Access Compliance Report

Public Rights-of-Way

Intersection ID: 47834	Main Street: ALVARADO_WY	Cross Street: CAMP_VERDE_LN	Location: S
ADA ID: 3F147B0ED552	Ramp Type: PerpDiag	Initial Pass/Fail: Fail	Overall Compliance: No
Severity Score: 8.75			
Codes/Mitigation Info/Possible Solution		Field Measurements/Component Compliance

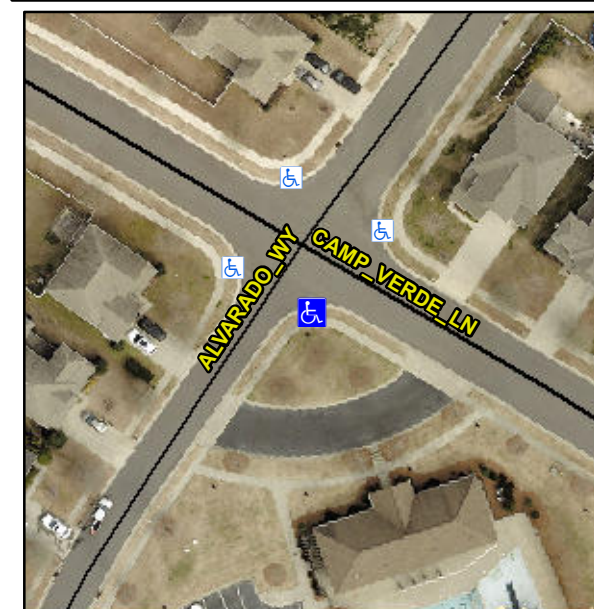
Not Found, R304.5.1

Compliance	Description	Data	Compliance	Description	Data
N/A	Ramp Length (in)	52.0	Yes	Ramp Slope (%)	5.0
No	Ramp Width (in)	46.0	Yes	Ramp XSlope (%)	1.5
N/A	Flare Type LT	N/A	N/A	Flare Type RT	N/A
N/A	Flare Slope LT (%)	N/A	N/A	Flare Slope RT (%)	N/A
N/A	Flare Traversable LT?	N/A	N/A	Flare Traversable RT?	N/A
N/A	Landing Length (in)	N/A	N/A	DWS Provided?	N/A
N/A	Landing Width (in)	N/A	N/A	DWS Contrast?	N/A
N/A	Landing Slope (%)	N/A	N/A	DWS Length (in)	N/A
N/A	Landing X Slope (%)	N/A	N/A	DWS Full Width?	N/A
N/A	Landing Curb? (Y/N)	N/A	N/A	DWS Offset (in)	N/A
N/A	Shared Landing?	N/A			
N/A	Gutter Ponding?	N/A	N/A	Gutter Slope (%)	N/A
N/A	Gutter Lip Ht (in)	N/A	N/A	Gutter X Slope (%)	N/A
N/A	Painted X Walk1?	No	N/A	Painted X Walk2?	No
	X Walk 1 Direction	To NE		X Walk 2 Direction	To NW
N/A	X Walk 1 Width (in)	N/A	N/A	X Walk 2 Width (in)	N/A
	X Walk 1 Slope (%)	2.0		X Walk 2 Slope (%)	1.8
	X Walk 1 X Slope (%)	0.6		X Walk 2 X Slope (%)	1.4

Remove & Replace Curb Ramp With Two New Directional Ramps or Equivalent.
